Re: *Addendum No. 2*
Martin's Run Pump Station & Detention Basin Improvements
City of Lorain, OH

Date: August 24, 2026

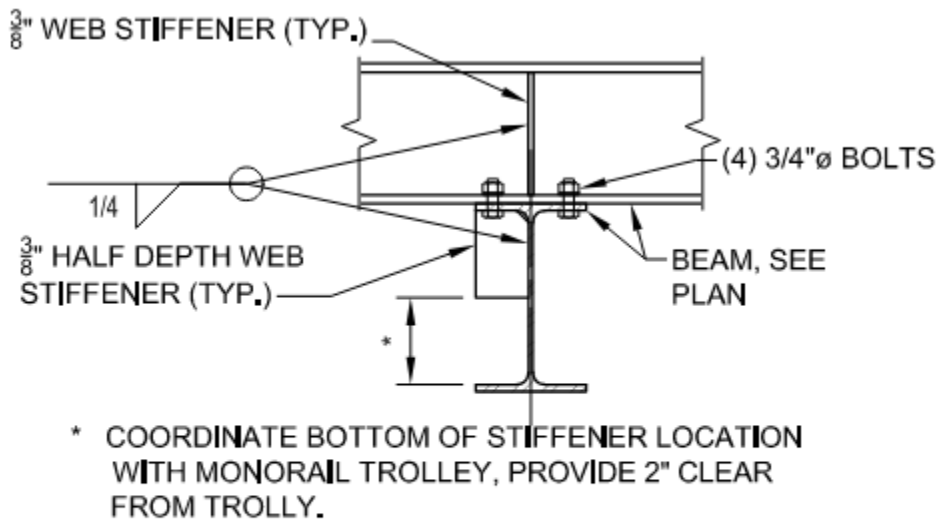
On plan sheet 30S-03, see the red clouded areas for the additional notes added to the Partial Roof Framing Plan:

A32. The call A and B have been removed. At the location of A, a note has been added about roof over framing with pre-fabricated wood roof trusses. See attached partial plan.

4 SECTION
 30S-06 SCALE: 3/4" = 1'-0"

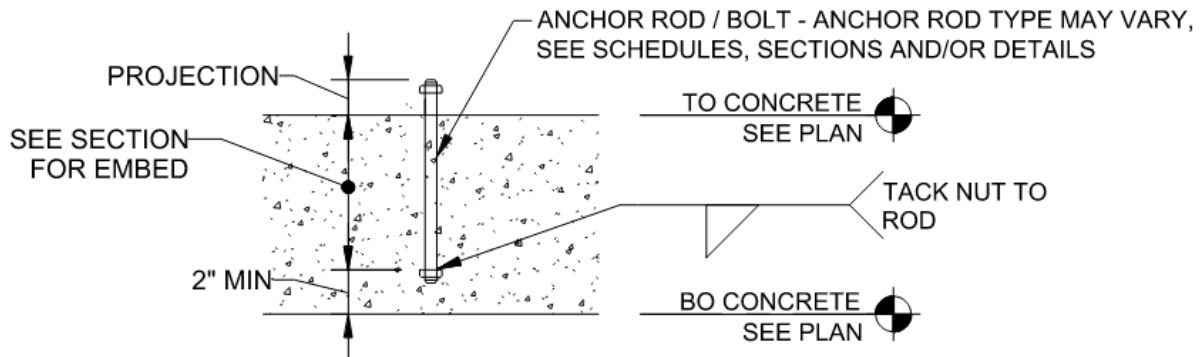
On plan sheet 30S-30, replace part of Section 4 with the following.
